DELEGATED APPLICATION REPORT

Application No: 210526/FUL

Address: 220 Elgar Road South, Reading

Proposal: Residential redevelopment comprising demolition of existing single storey building and erection of 16 dwellings together with associated works

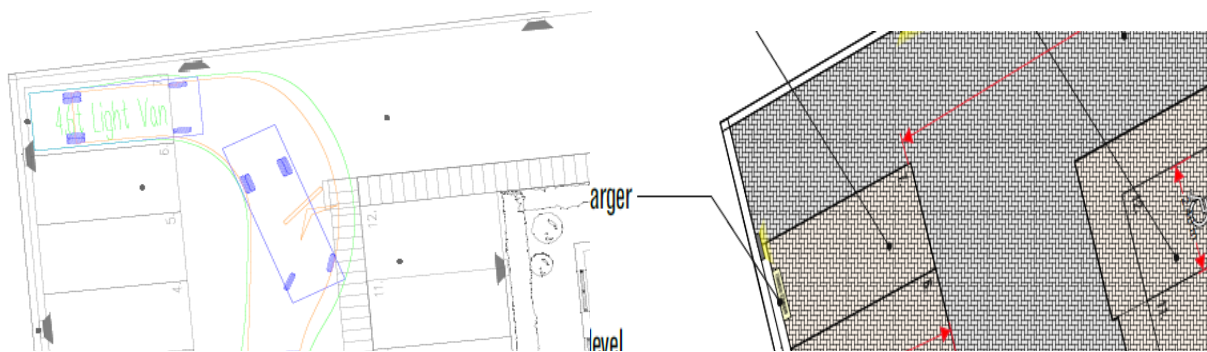
In accordance with the adopted Parking SPD, the development would be required to provide the following parking and cycle provision.

space. This falls short of the Council's current standards. Given that there are areas where on street parking is unrestricted the parking provision will need to comply with the Council's current standards, Transport would not support an increase of on street parking.

Typical Cycle Layout

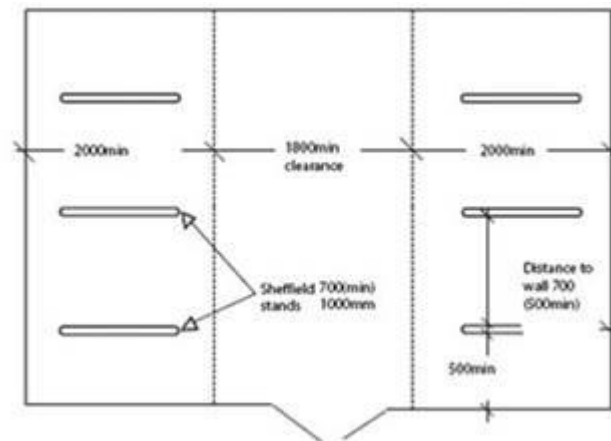
In accordance to the current Council's Standards 10 cycle parking standards (rounded up from 9.5) would be required for the development. The site plan states 10 spaces would be provided which would comply with the standards, however the size of the proposed storage unit would not facilitate 10 Sheffield type stands. Stands should be set back a minimum of 500mm from the wall as per the diagram below and there should be 1m between each bike.

A Josta style storage unit can also be considered, which would require a height of 2.8m. Revised plans required.
